DOCKETED	
Docket Number:	01-EP-10C
Project Title:	Enterprise Emergency Peaker Project - Compliance
TN #:	268054
Document Title:	CEC Data Response - Enterprise Hazardous Materials, Worker Safety, and Fire Protection - Vol 1_Body through App B
Description:	Response to Data Request for Enterprise Emergency Peaker Project, Docketed Date 11/4/2025 (Volume 1 of 3).
Filer:	Grace Myers
Organization:	Rincon Consultants, Inc.
Submitter Role:	Applicant Consultant
Submission Date:	12/29/2025 12:17:16 PM
Docketed Date:	12/29/2025

Enterprise Emergency Peaker (01-EP-10C)
Enterprise BESS Project

CEC Hazardous Materials Management/Worker Safety
and Fire Protection Data Request
Response No. 2

Battery Container Gas Detection System Schematic and Description

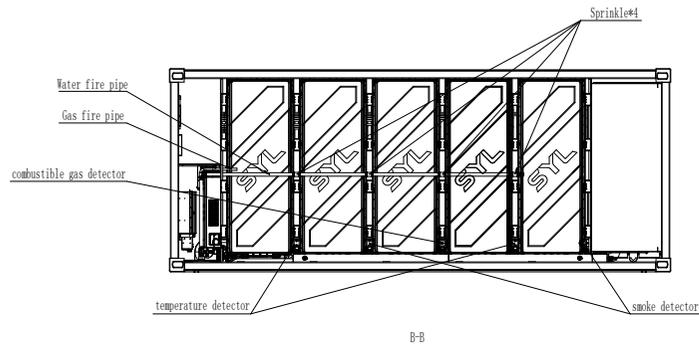
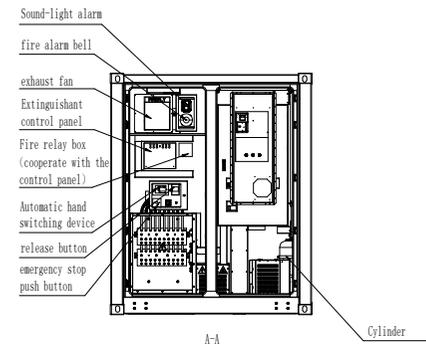
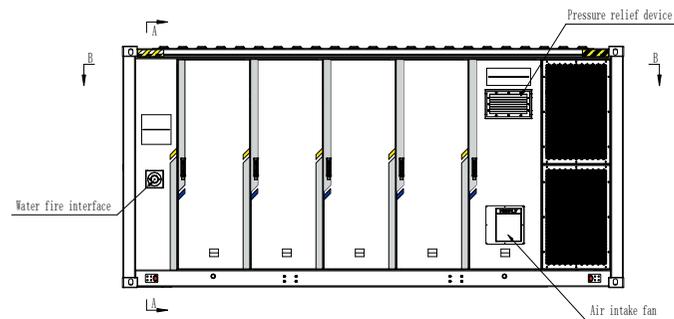
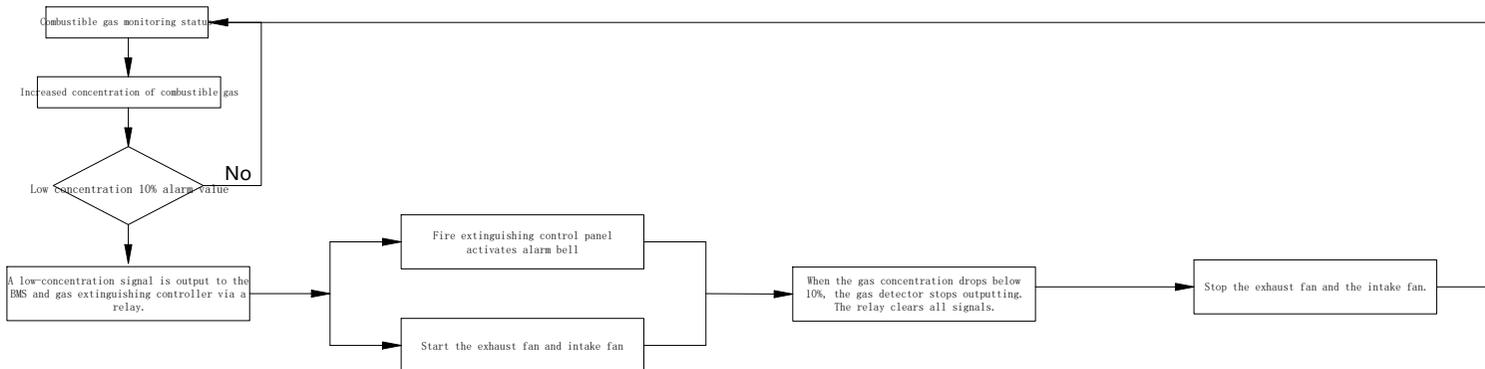
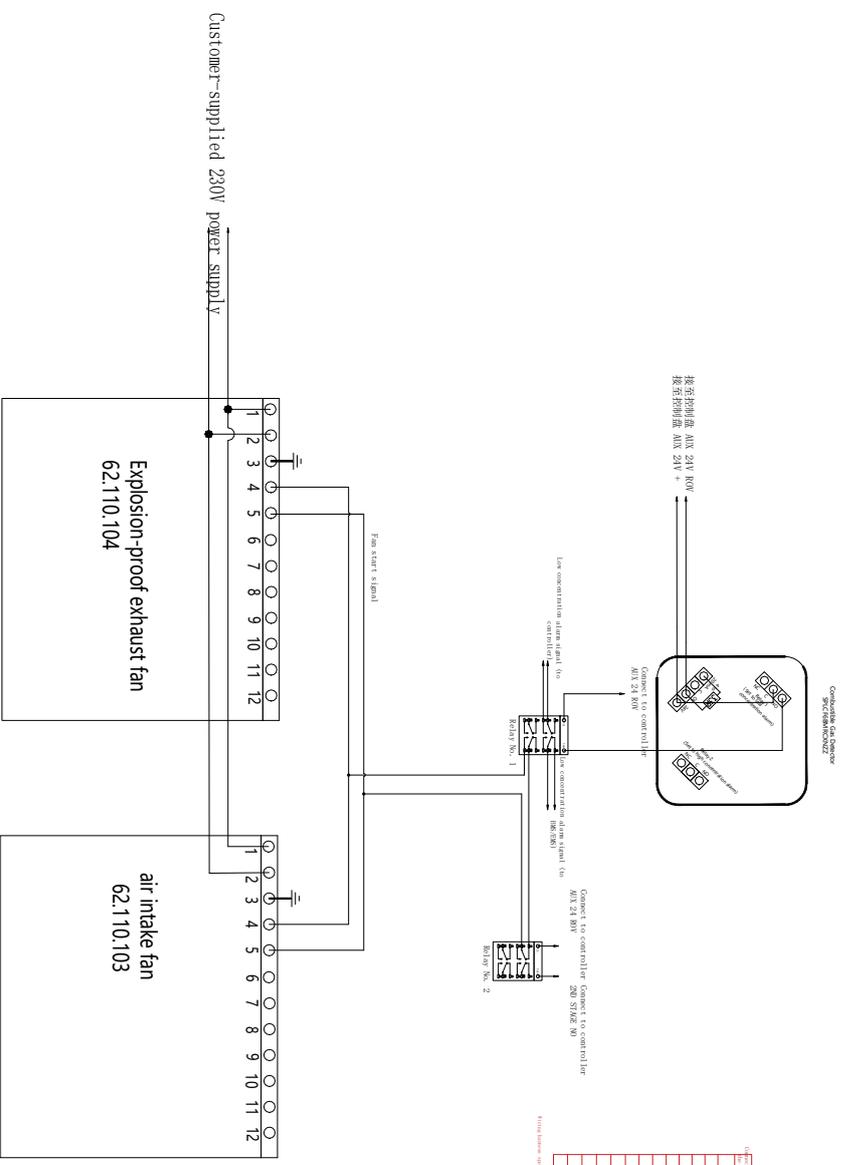
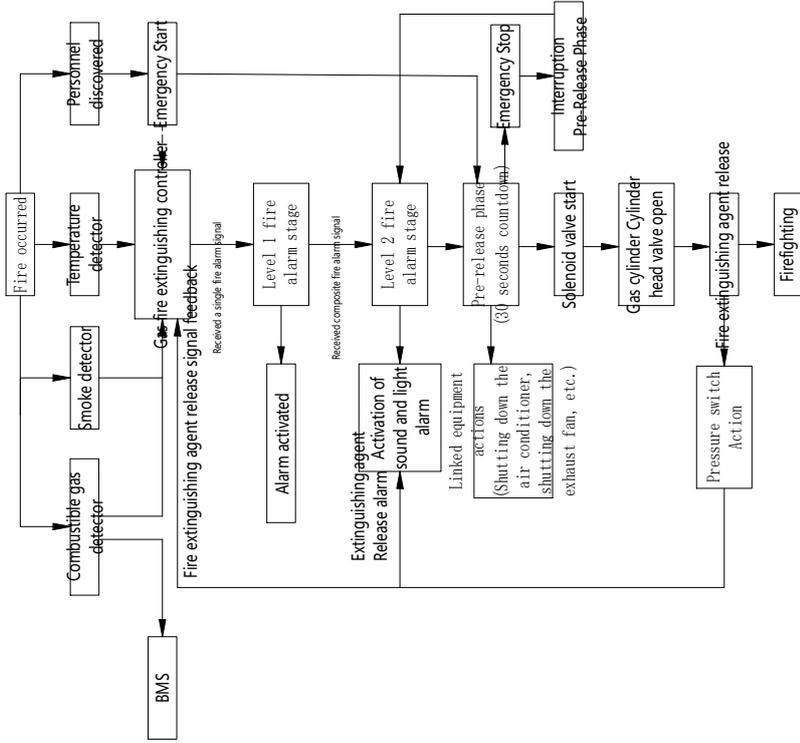
- **DR-3:** Provide a schematic of the proposed battery container gas detection systems and a detailed description of these systems. Provide a discussion of the specific gas(es) or vapor(s) intended to be detected.

Response: The schematic and description of the proposed battery container gas detection system is included in Appendix B. Detailed description of battery container gas detection systems is located in Section 3.4 of the Hazard Mitigation Analysis prepared by Coffman Engineers (Appendix C).
